Rec: 6/15/07
PGR-005

Concerning the Palisades-Goshen Rebuild Project

Proposal 2

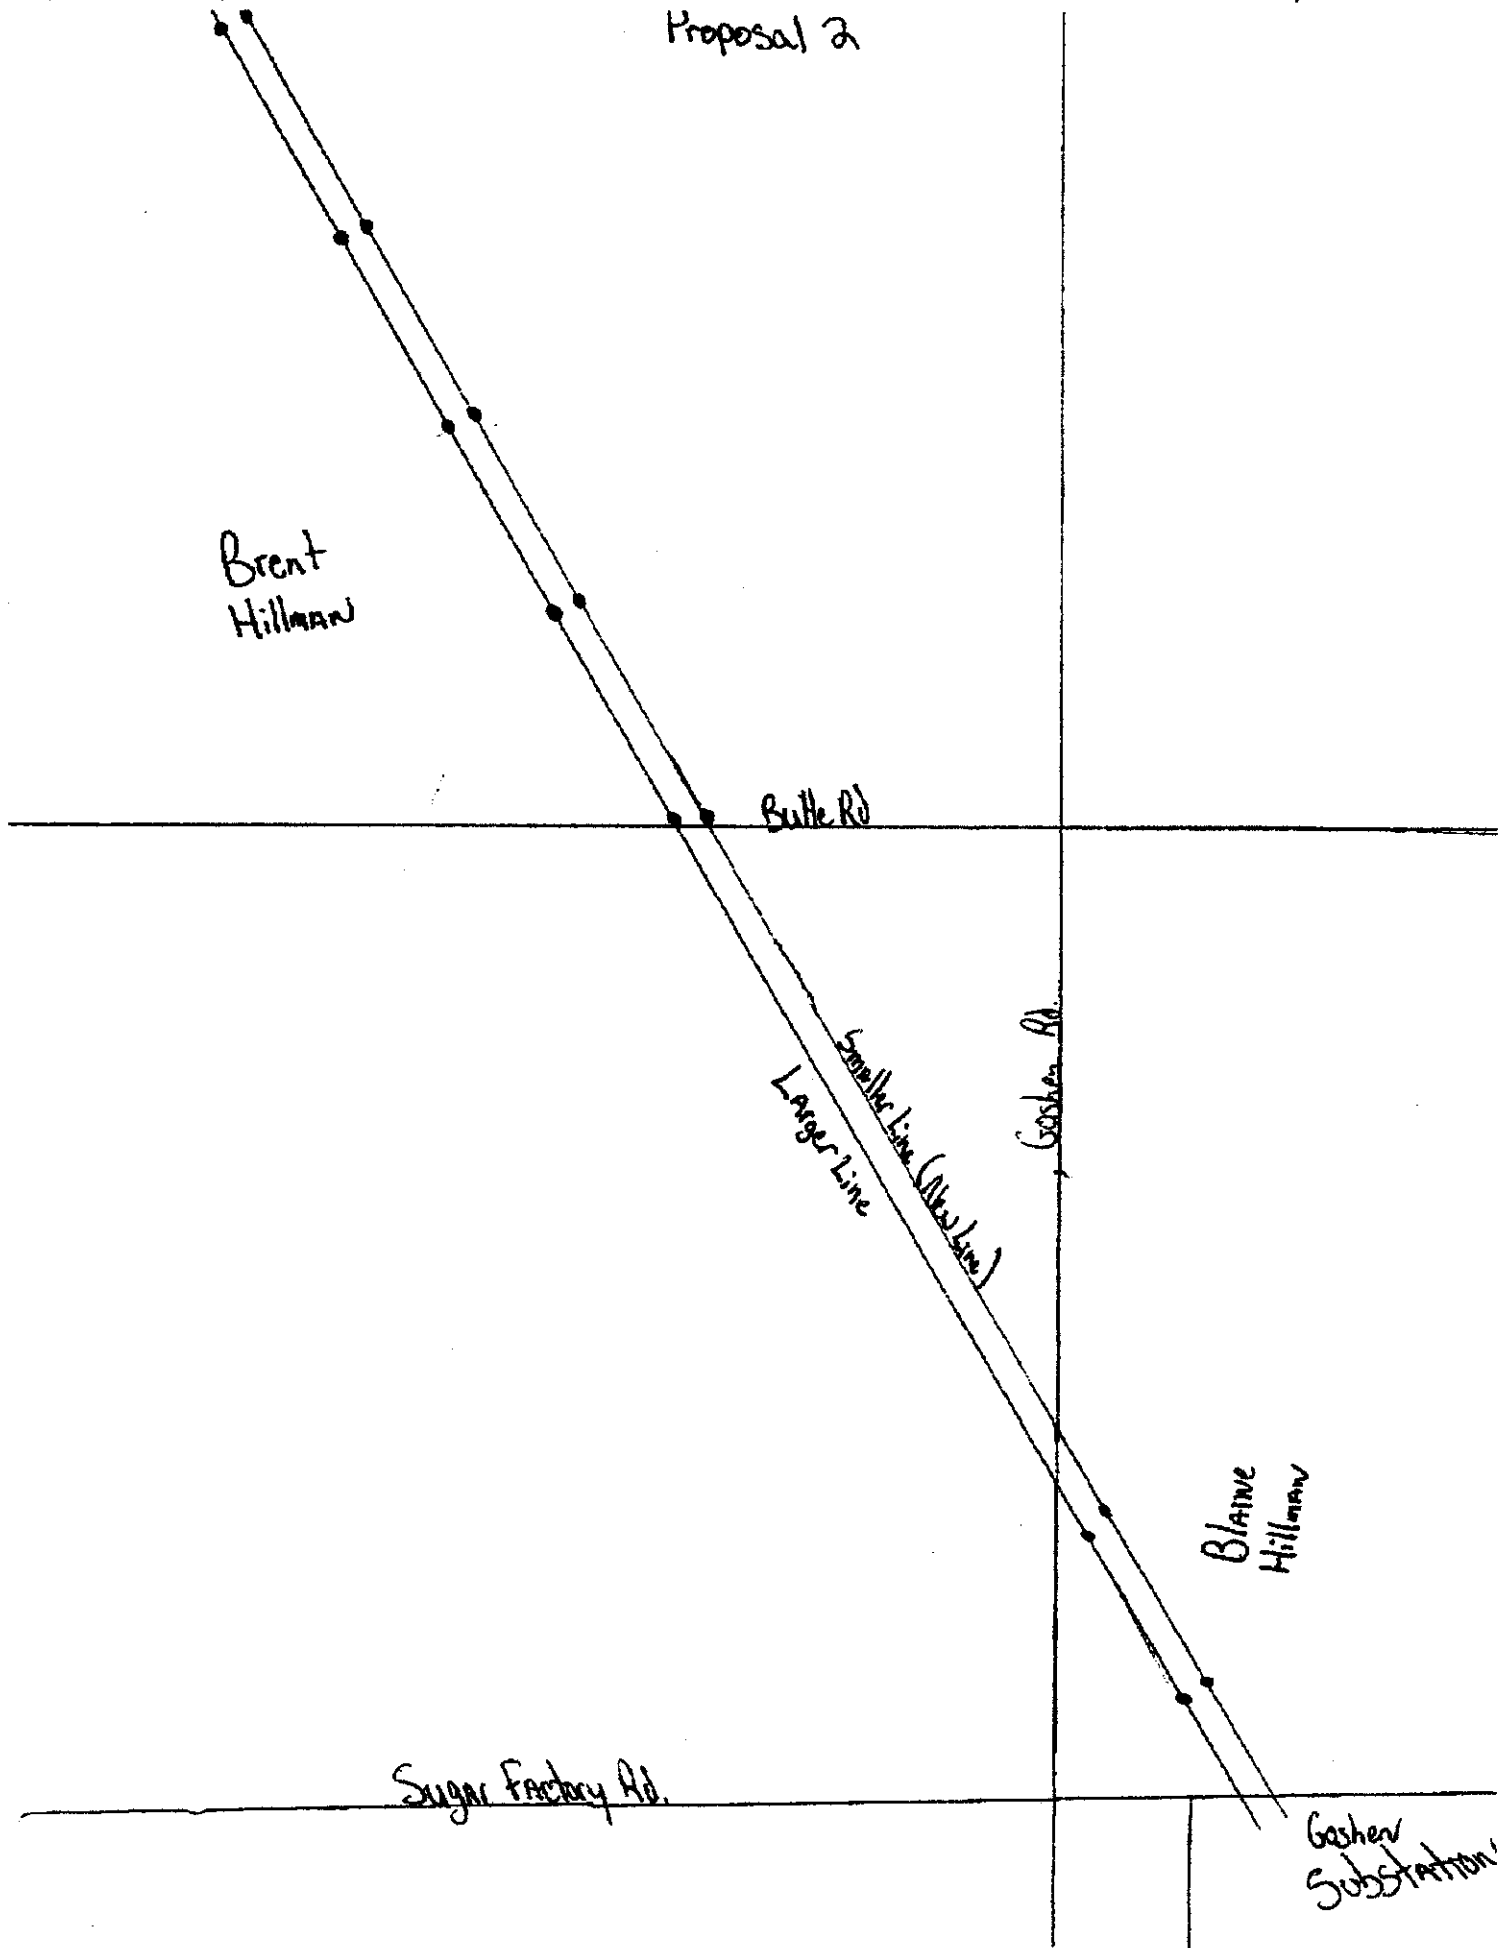
If Proposal 1 is absolutely impossible, Proposal 2 would have the new poles line up with the larger poles so that the irrigation systems would at least be able to irrigate more of the ground that the existing structure would make us waste. Proposal 2 attached

Proposal 1

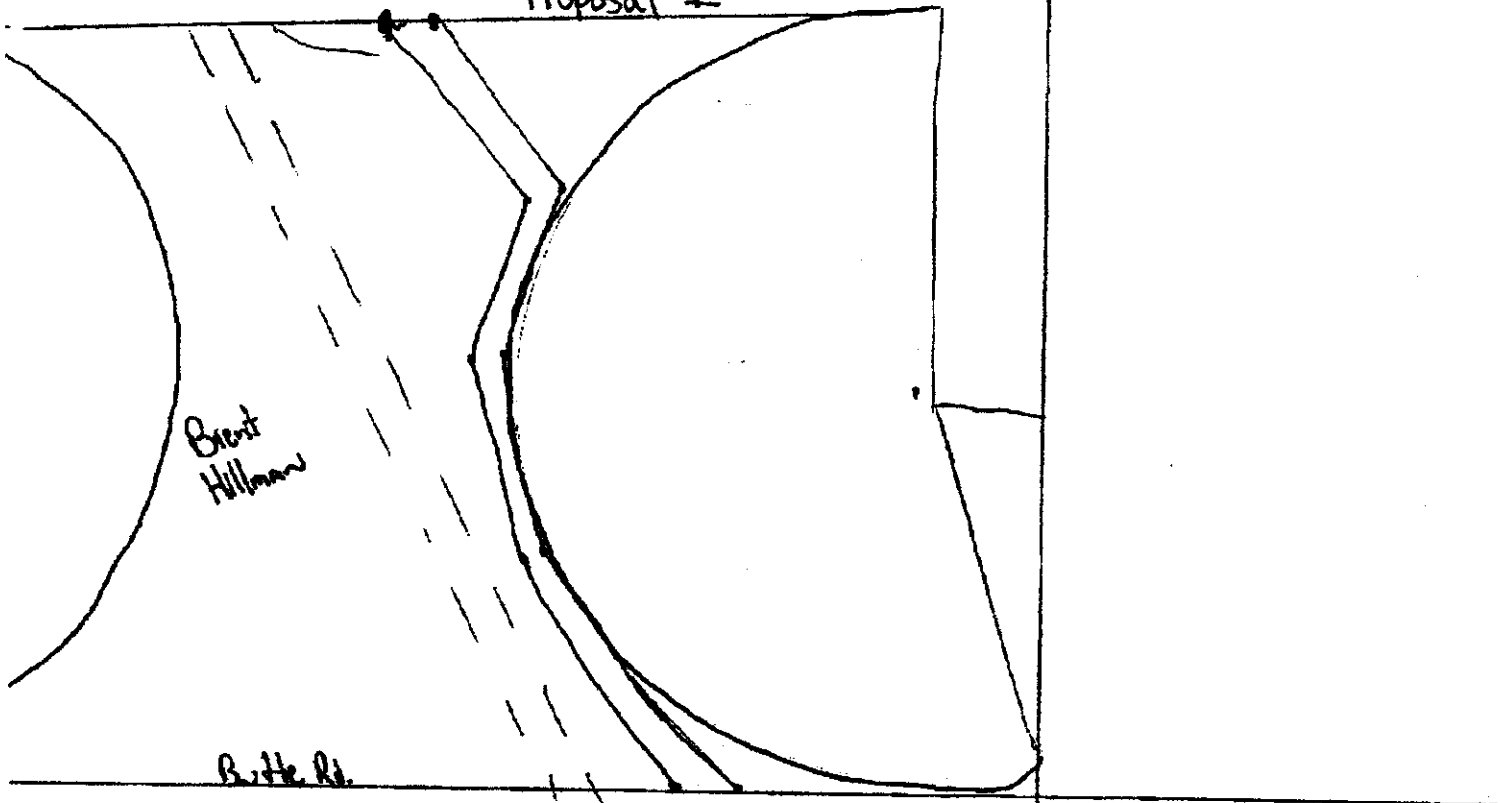
We understand that you are planning on rebuilding the smaller of the two lines running through our farms. Our first proposal and preference would be that you would relocate some poles on the larger line as well as the smaller line to accommodate the current irrigation systems. Proposal 1 image attached
